THE PADDINGTON SOCIETY Inc.
For Community and Heritage
Est 1964

16 December 2013

**CBD and SOUTH EAST LIGHT RAIL
ENVIRONMENTAL IMPACT STATEMENT
PADDINGTON SOCIETY SUBMISSION**

Figure 5.25 Section thru proposed Moore Park stop

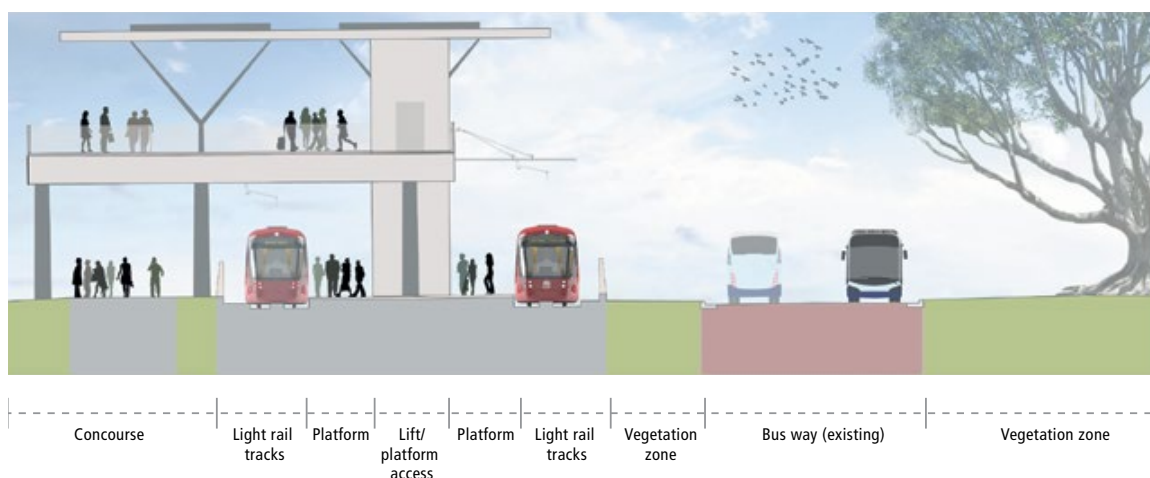
- The Moore Park stop, in particular should be minimal yet striking in design – we recommend a design competition for this important building; the need for 2-storeys during events should be reconsidered, as this adds to the visual bulk.

It is recommended that the light rail run in the existing bus way corridor, with wire-free vehicles, and that the stop structure is single storey.
